MIL ON P140018 - Loose Pin Tension at EGR Connector

Service Category Engine/Hybrid System

YEAR(S)	MODEL(S)	ADDITIONAL INFORMATION
2021 - 2024	Camry	
2021 - 2025	RAV4

Introduction

Figure 1.

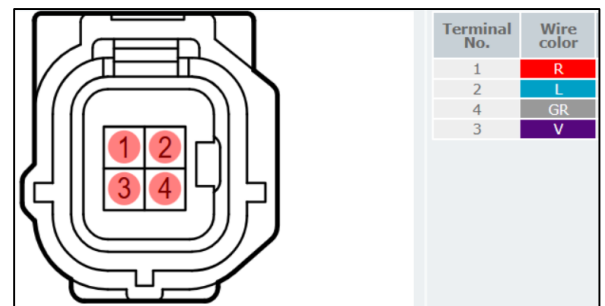
2. Inspect C90/C27 connector at EGR valve and confirm if there are one or more loose terminals as seen in Figure 1. (Often terminal #4 is found to be loose but inspect all four as more than one terminal may be of concern). Are there one or more loose terminals?
 - **YES** — Continue to the applicable step according to the model applicability.
 - A. For RAV4, continue to step 3.
 - B. For Camry, continue to step 4.
 - **NO** — This bulletin does NOT apply. Continue diagnosis using the applicable Repair Manual.

Figure 11. Wire Wrapped in Electrical Tape

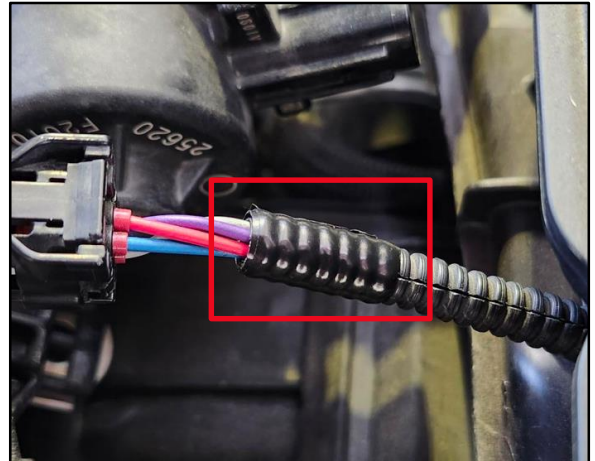
5. Do not reinstall outer connector cover.
6. Using electrical tape, wrap the end of wire loom to secure it (see photo).
